LEGAL ADVERTISEMENT PORTLAND PLANNING BOARD MEETING

AGENDA PORTLAND PLANNING BOARD MEETING

PLANNING BOARD REPORT PORTLAND, MAINE

Submitted to: Portland Planning Board: Public Hearing Date: June 14, 2016	Prepared by: Shukria Wiar, Planner Date: June 10, 2016
--	---

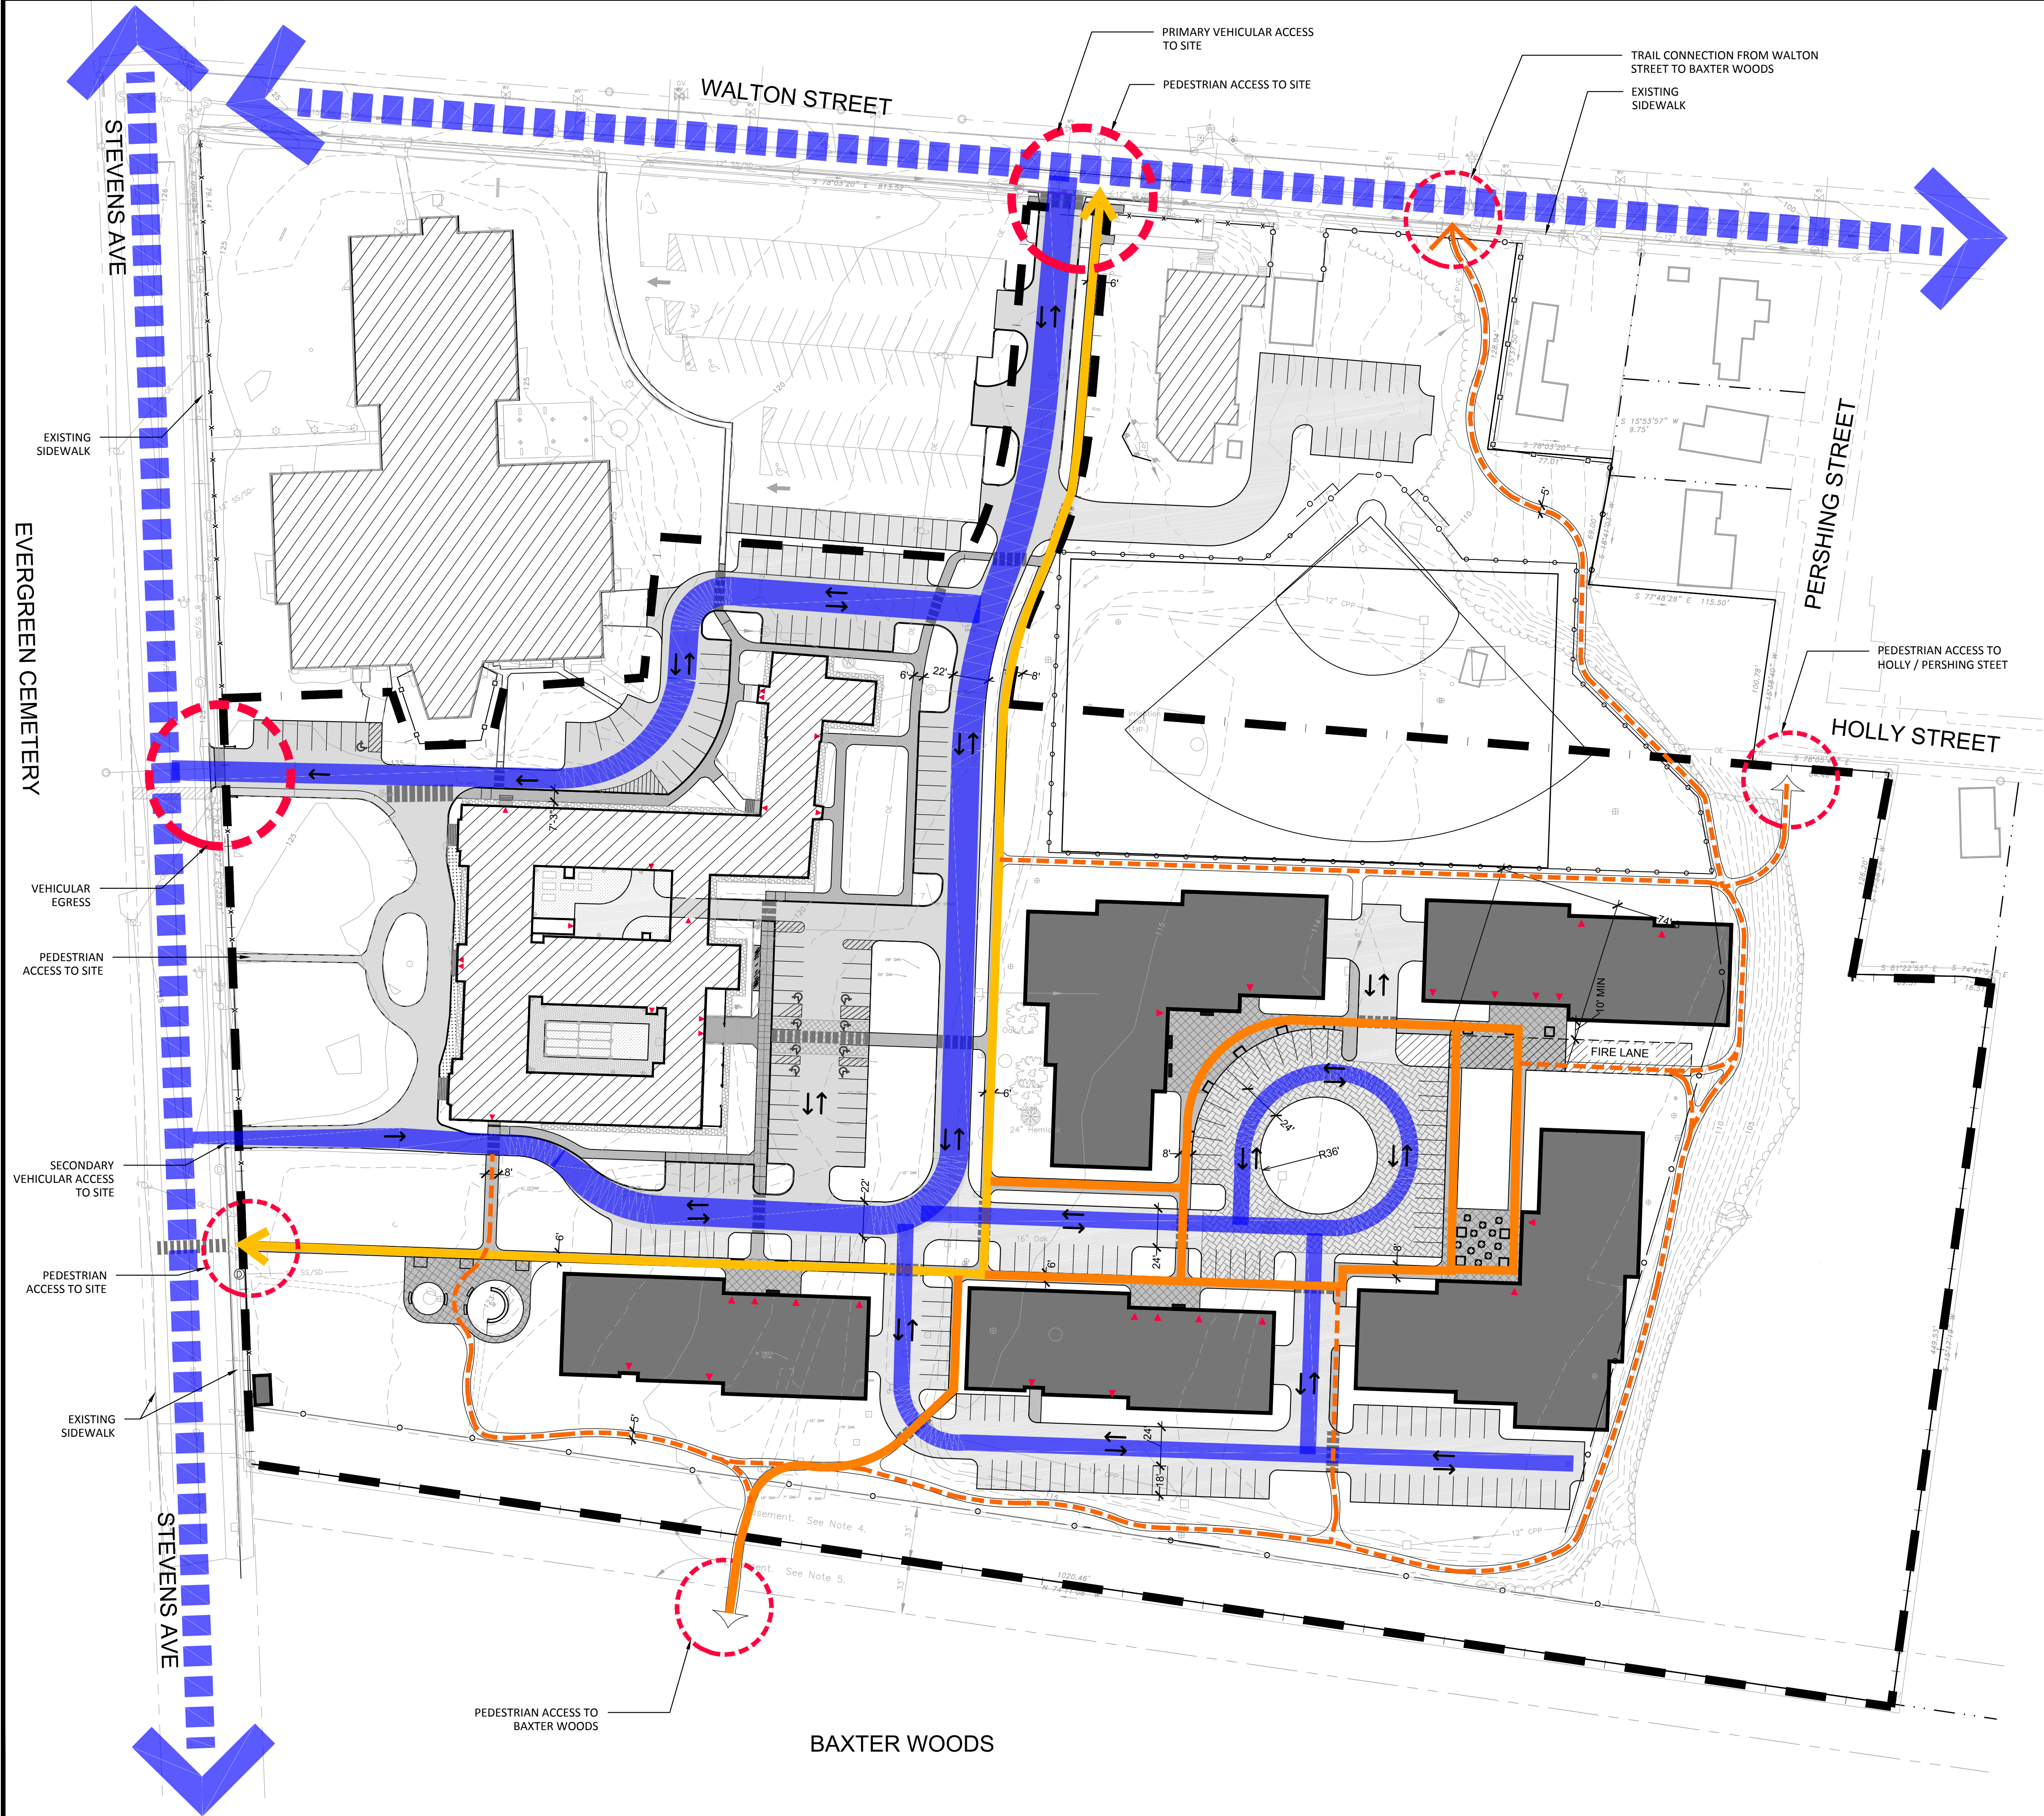
- c. Sheet L-2 Site Plan does not match Sheet C-3.0 Concept Stormwater Plan. The site plan identifies rain gardens as part of its legend, but locations corresponding to the concept stormwater plan are not shown. Some landscaping features and a potential community garden are shown in areas where stormwater features are proposed. The Site Plan should be updated to reflect the current proposed stormwater management features.

- A future potential future pedestrian connection shown to Holly Street.
- The fire access between buildings 3 and 4 has been emphasized on the Site Plan L2.0.

L-5.1

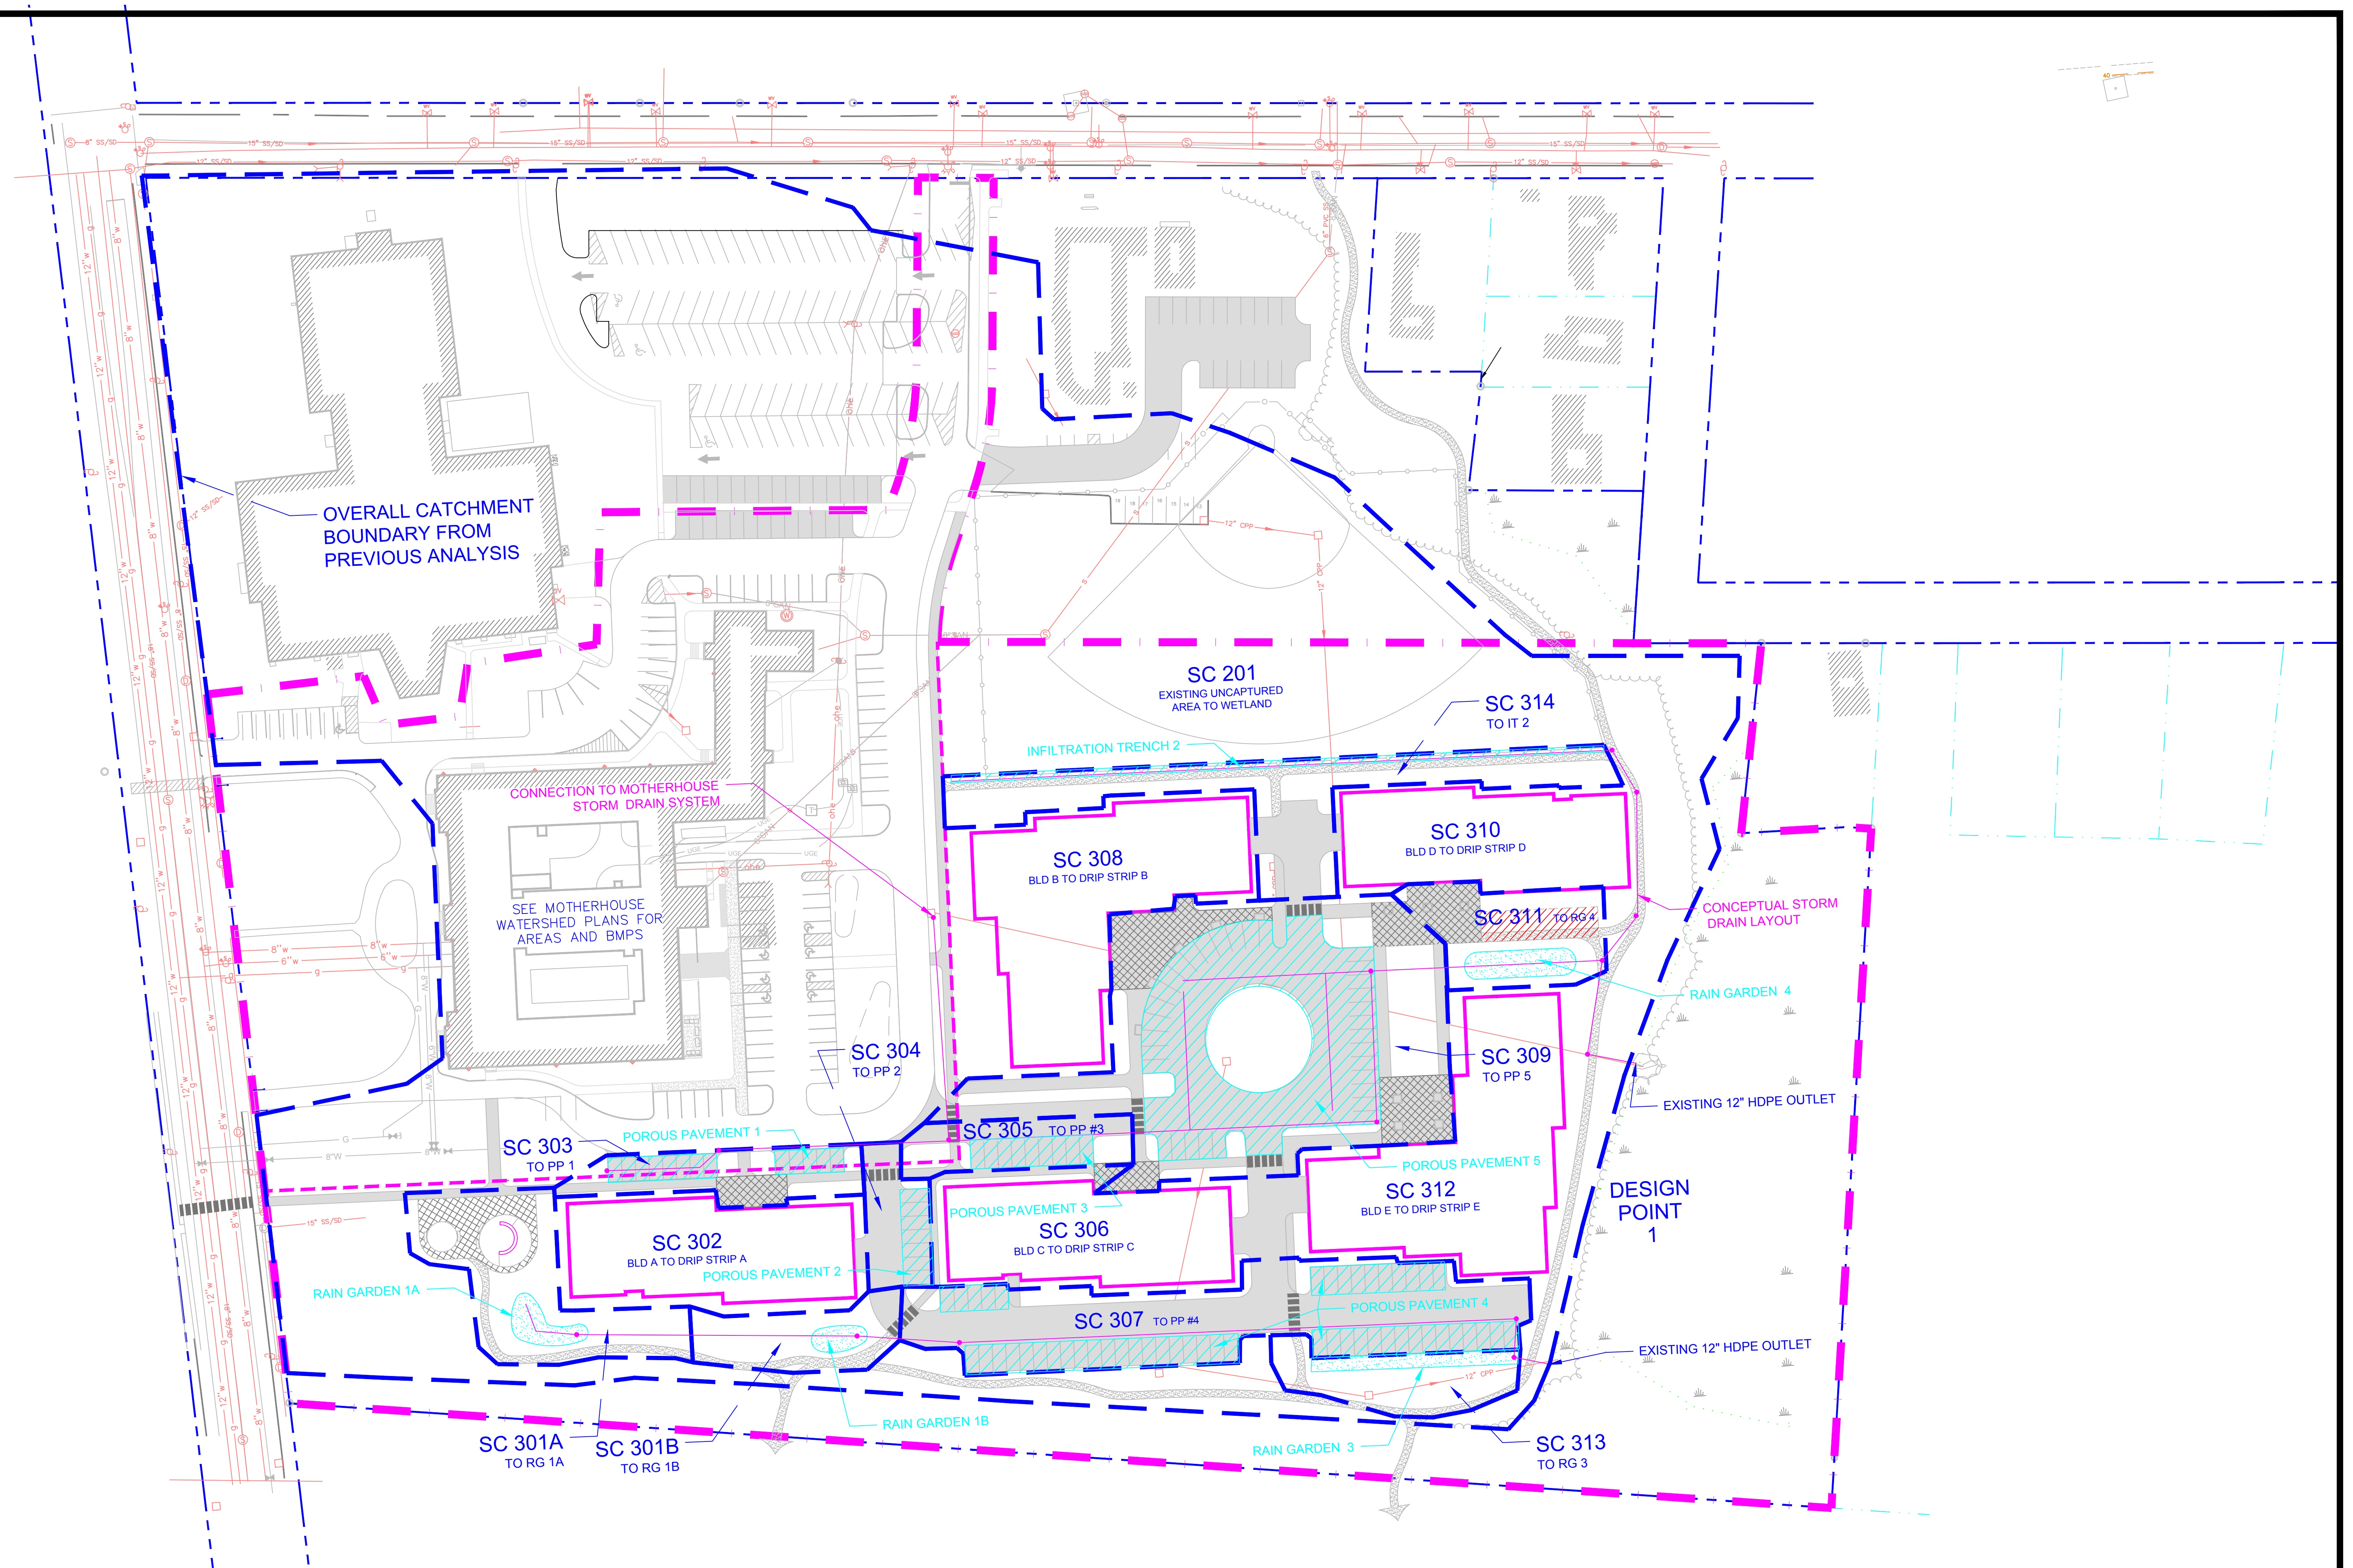
- Please address the comments of the City Arborist Jeff Tarling dated 4.22.2016 (attached) and the following additional comments from Jeff Tarling (5.4.2016):

- Plan L5.1 has been revised to provide additional infill planting along the buffer to Baxter Woods on either side of the fence line. Native plant materials will be utilized and reviewed with Jeff Tarling, City Arborist. Final planting lists will be developed at the Site Plan review phase.
